ADDENDUM IV

Date of Addendum: April 29, 2022

Project Name: UNCW Randall Library Expansion and Renovation

SCO # 18-19656-02A

SHEET:
MU002

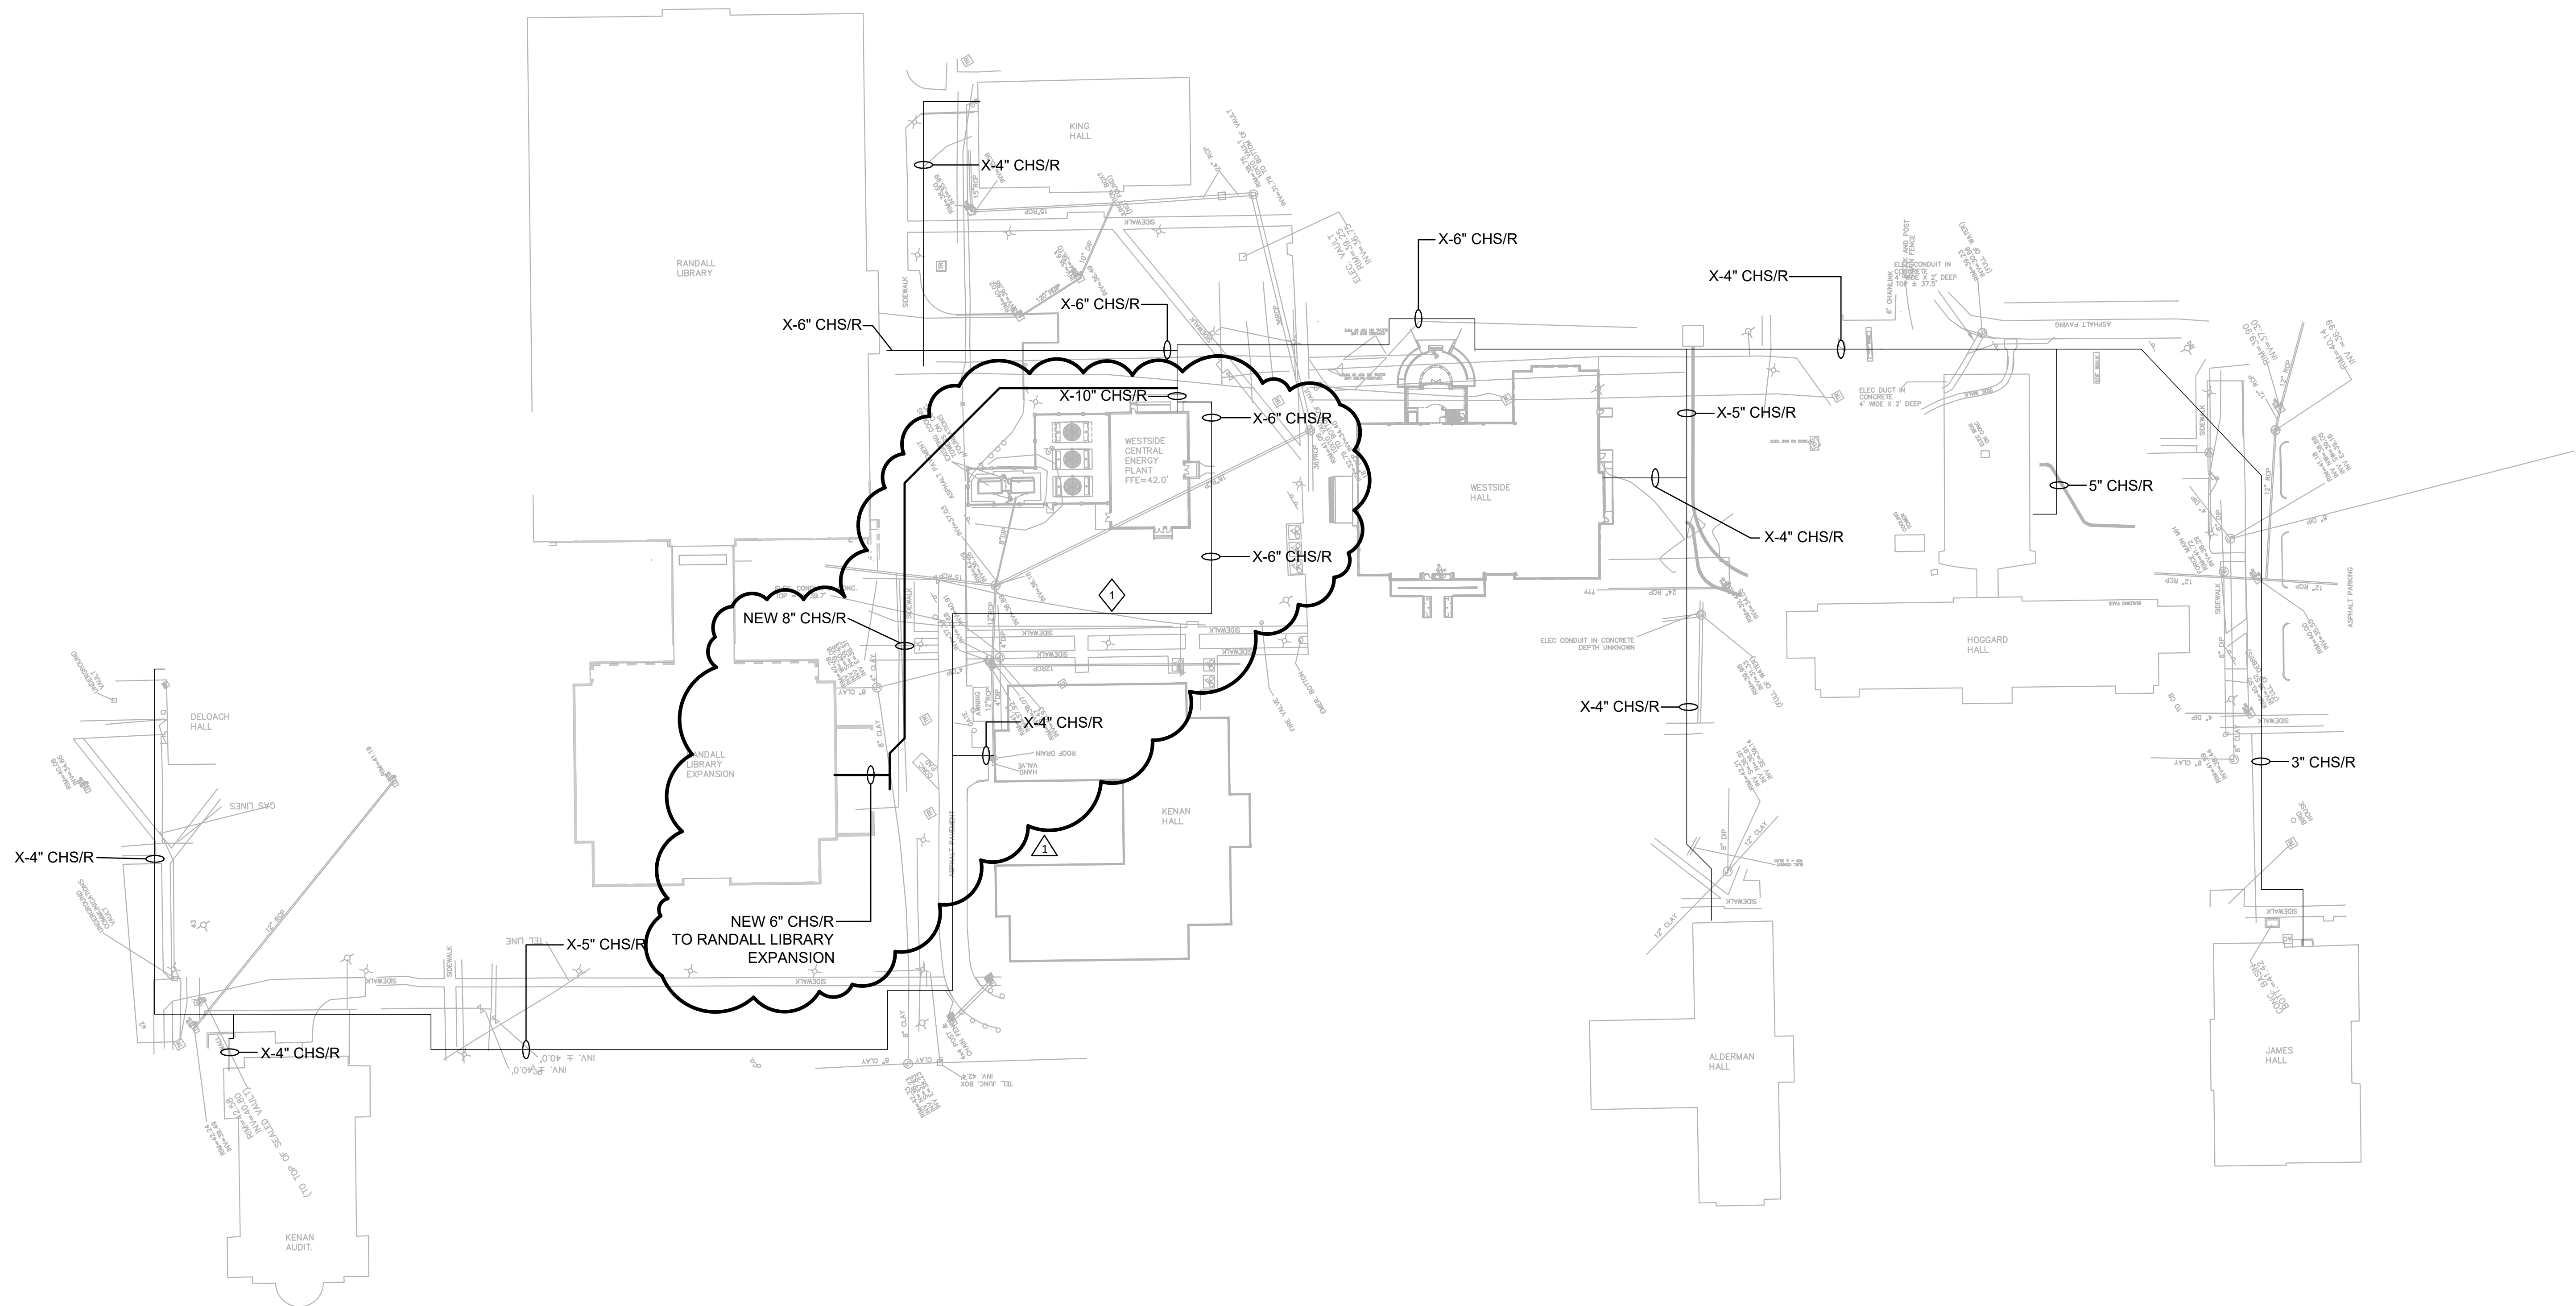
Item IV-10. Sheets MU002, MU003, MU100, MU101, MU102, MU103, MU104: Replace with revised sheets, included. Updated thermal utility routing per UNCW direction.

SHEET:
EU105

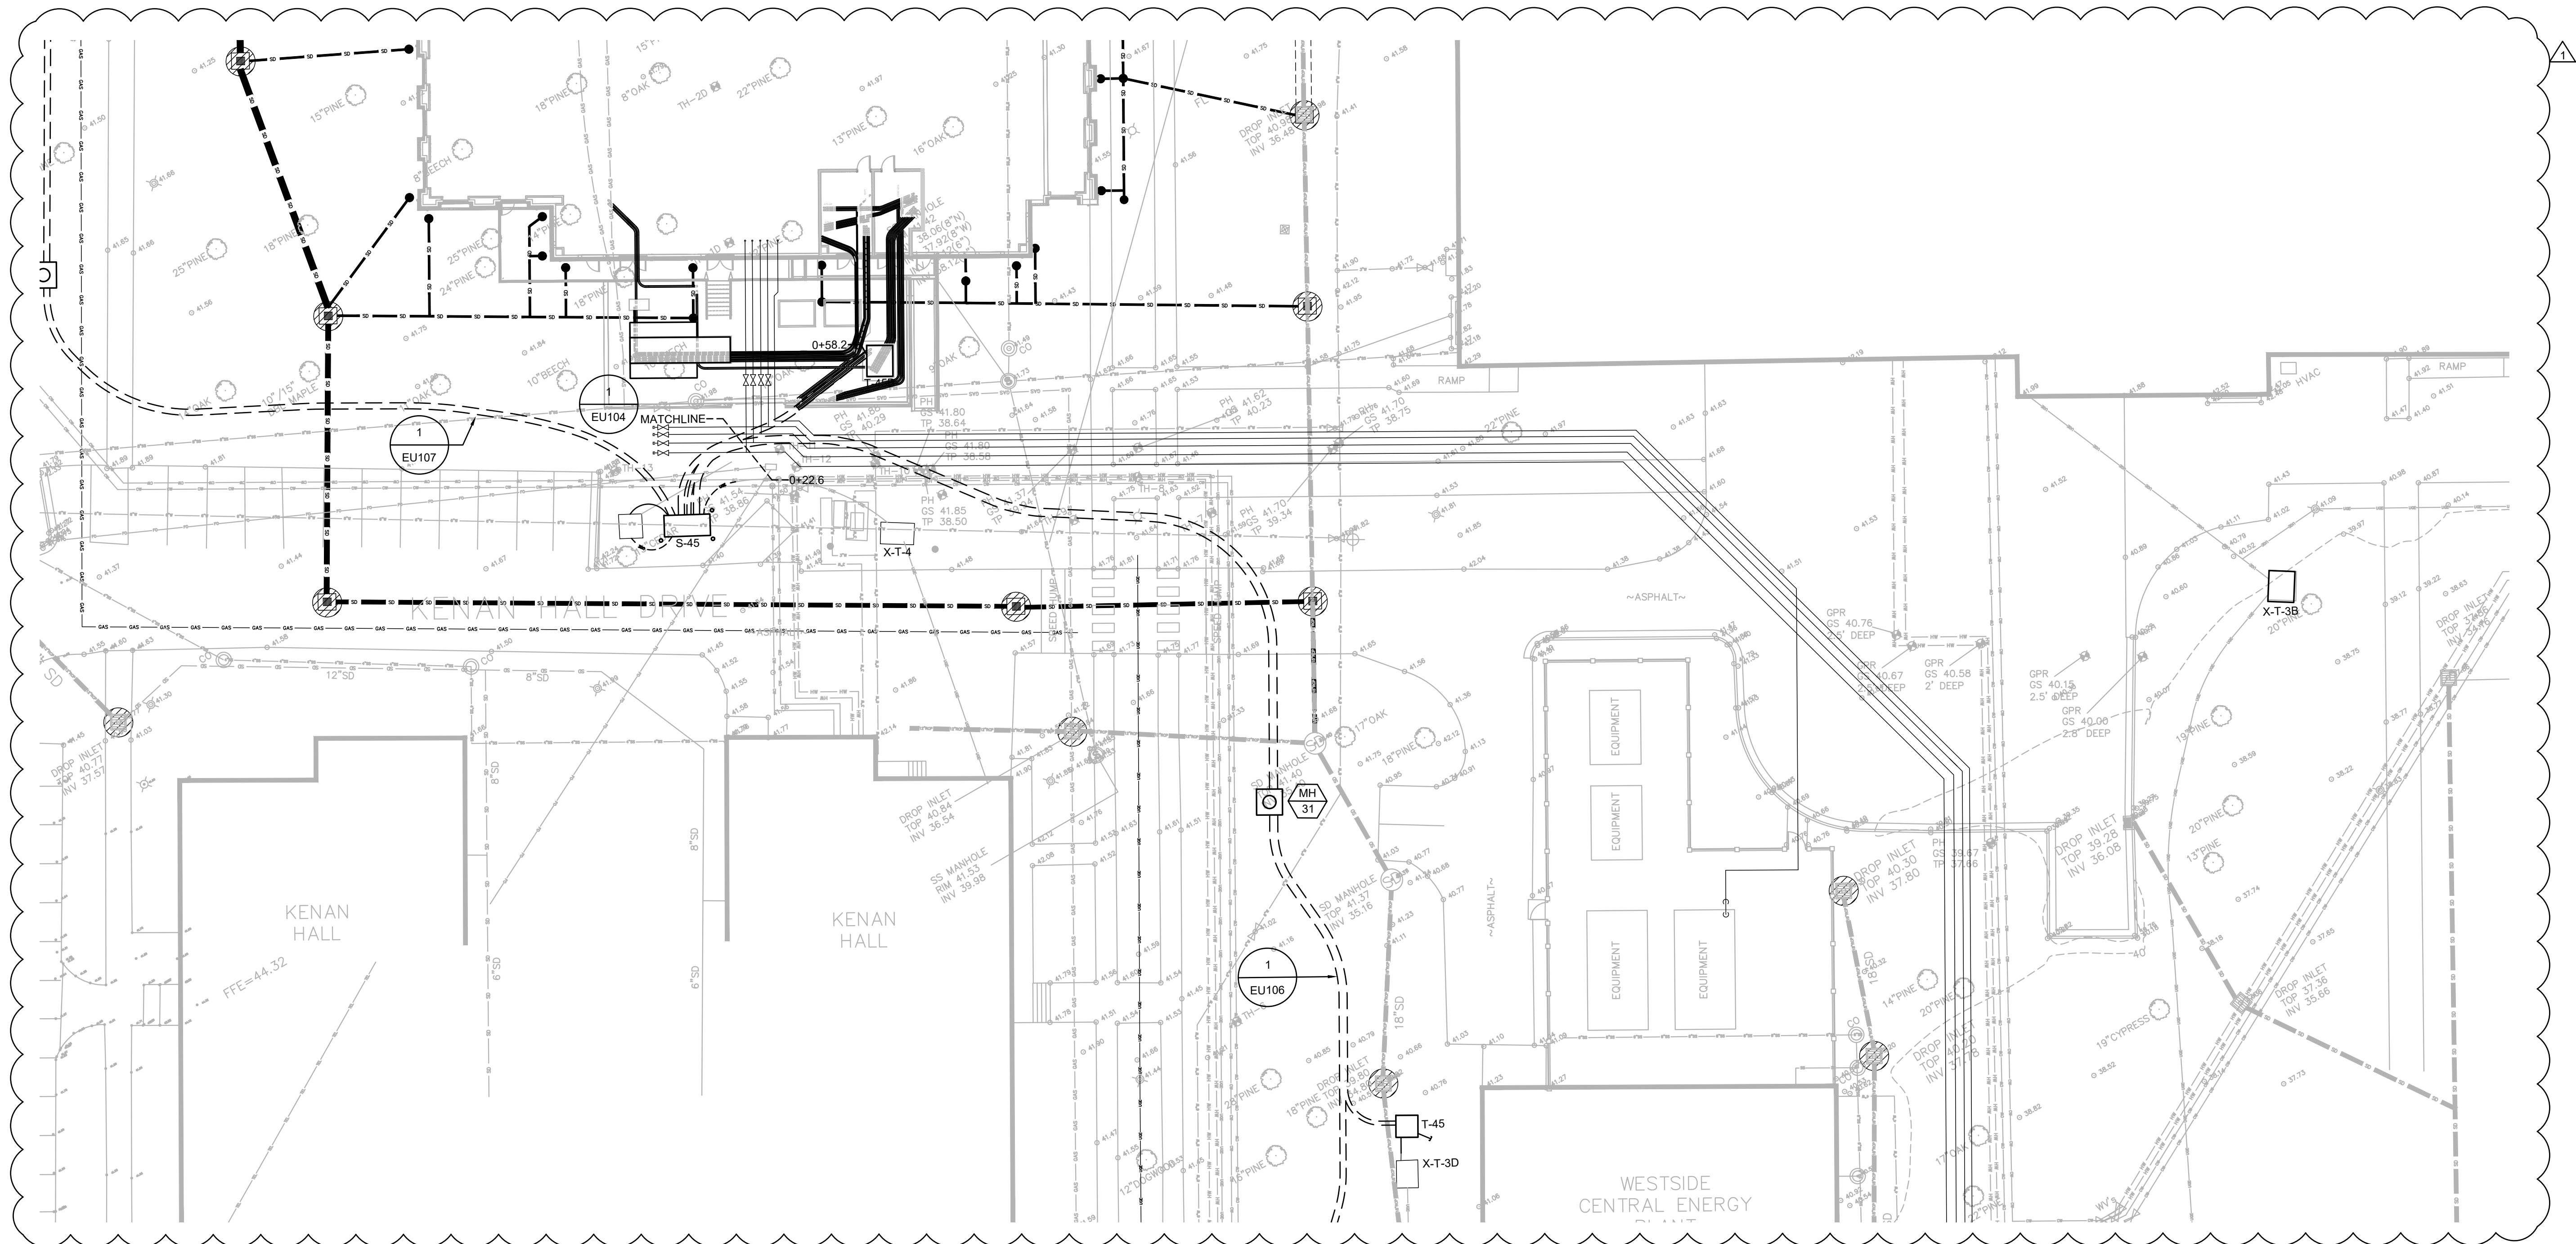
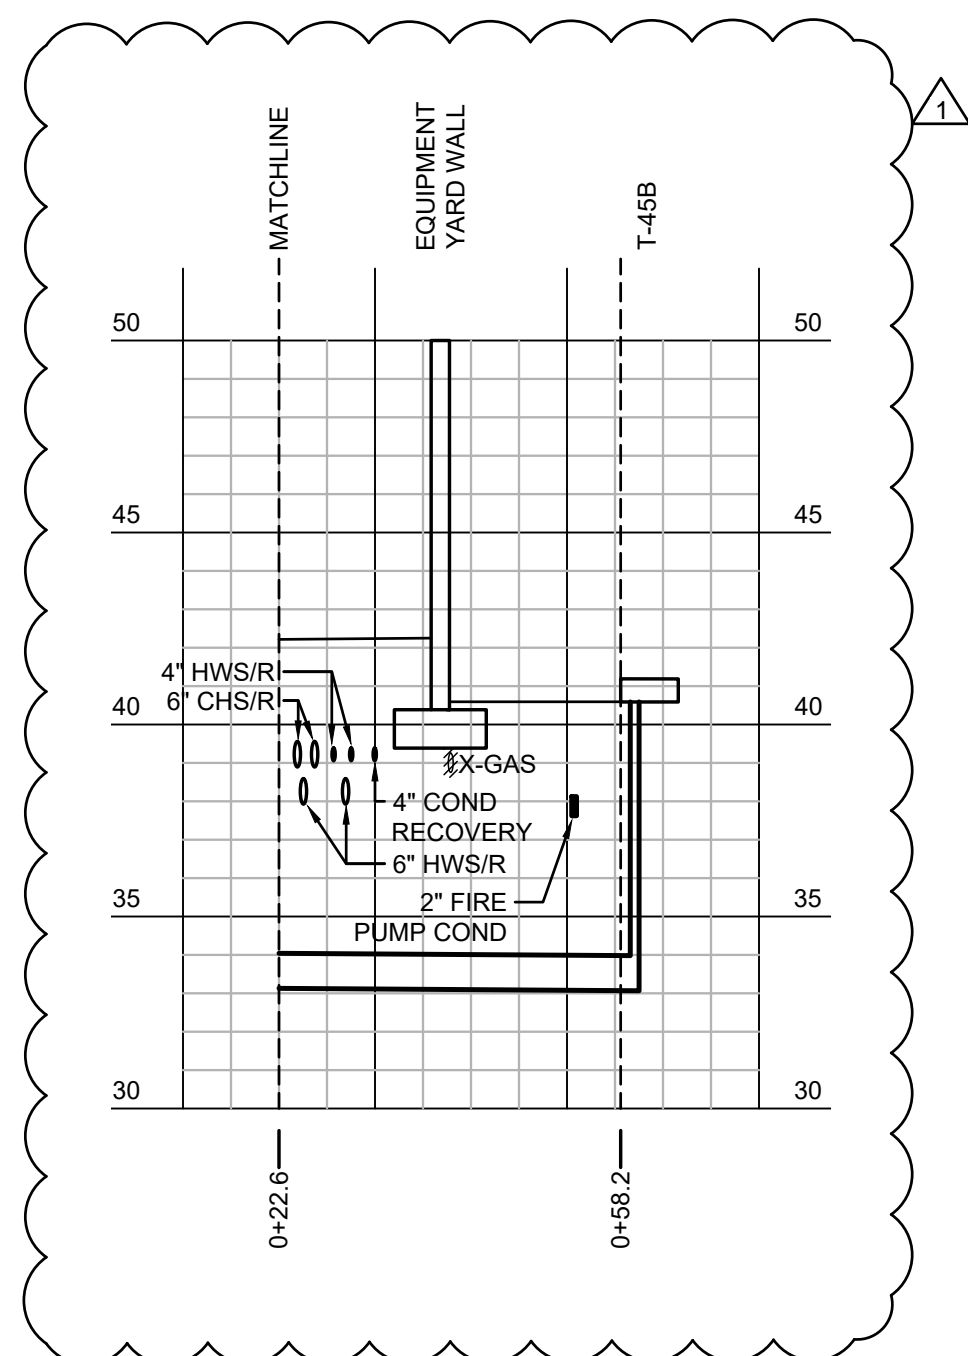
Item IV-11. Sheets EU100, EU102, EU103, EU104, EU105, EU106, EU107 EU108: Replace with revised sheets, included. Updated utility routing per UNCW direction.
